Project	IEEE 802.16 Broadband Wireless Access Working Group < http://ieee802.org/16 >	
Title	Normal MAP Extension for H-ARQ	
Date Submitted	2005-01-26	
Source(s)	Yigal Eliaspur, Yuval Lomnitz, Zivan Ori	yigal.eliapsur@intel.com , yuval.lomnitz@intel.com , zivan.ori@intel.com
	Intel Corp.	geunhwi.lim@samsung.com , yongchang@samsung.com
	Geunhwi Lim, Jiho Jang, Wonil Roh, Yong Chang, Seungju Maeng	
		ran.yaniv@alvarion.com
	Samsung Electronics Co. Ltd.	
	Ran Yaniv Alvarion Ltd.	mhfong@nortelnetworks.com
	Mo Han Fong, Wen Tong Nortel Networks	bcihm@lge.com
	Bin-Chul Ihm LG Electronics, Inc.	mchion@ztesandiego.com
	Mary Chion, Irving Wang ZTE San Diego Inc.	scchang
	Seokheon Cho, Sungcheol Chang, Chulsik Yoon ETRI	ehosh@etri.re.kr
	Kamran Etemad Greg Schumaker Nextel Communications	jhumbe01@sprintspectrum.com
	John J. Humbert IV Sprint	radu@redlinecommunications.com
	Radu Selea, Bogdan Franovici Redline Communications

Re:	IEEE P802.16e/D5a	
Abstract	The document contains suggestions for extending the Normal MAP for H-ARQ support. Additionally, certain MAC functions are described for H-ARQ support.

Purpose	Adoption of proposed changes into P802.16e /D5a-2004
Notice	This document has b

Figure XX – H-ARQ downlink allocation

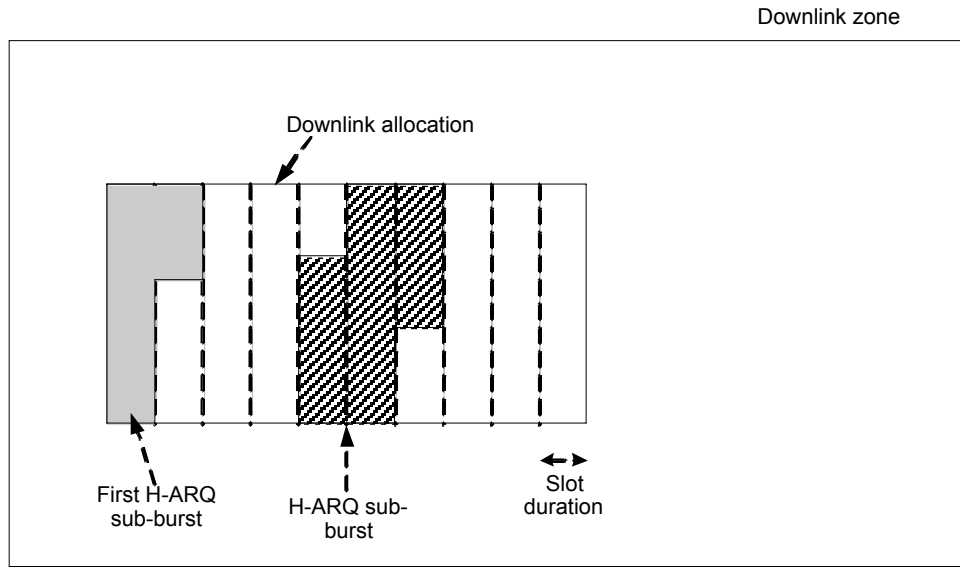
[Add a new section 8.4.5.3.20 9 as follows]

[The H-ARQ DL MAP IE defines one or more two dimensional data regions ~~allocations~~ \(a number of symbols by a number of subchannels\). ~~When the mode field indicates H-ARQ IR or Chase \(mode = 10,11\), t~~These allocations are further partitioned into bursts, termed sub-bursts, by allocating a specified number of slots to each burst. . All sub-bursts of a data region shall only support one of the H-ARQ modes. The number of slots is indicated by duration or \$N_{sch}\$ fields. The slots are allocated in a frequency-first order, starting from the slot with the smallest symbol number and smallest subchannel, and continuing to slots with increasing subchannel number. When the edge of the allocation is reached, the symbol number is increased by a slot duration, as depicted in the following diagram. Each sub-burst is separately encoded.](#)

Figure 23a Sub-MAP Burst

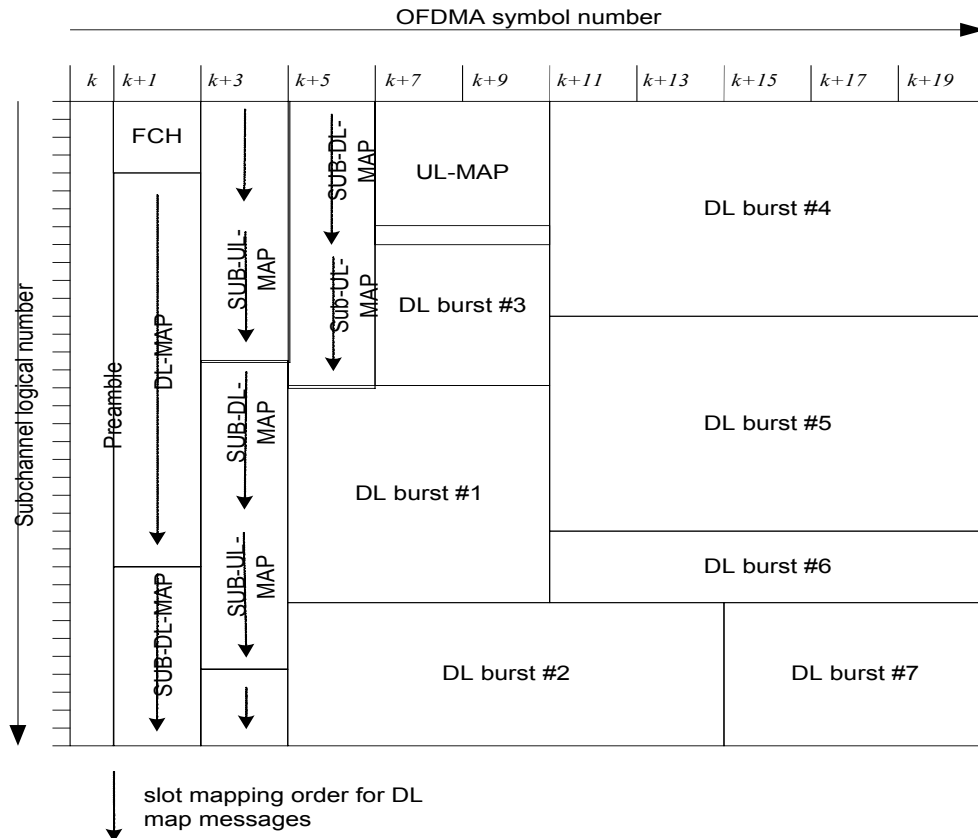
[Add new section 6.3.2.3.59]

6.3.2.3.59 Sub downlink/uplink map (SUB-DL-UL-MAP) message

The SUB-DL-UL-MAP message shall appear in a compressed form, in which the generic MAC header is omitted. This is indicated by setting the two most significant bits of the first data byte in the message’s PHY burst to 1 (an invalid combination for a generic MAC header).
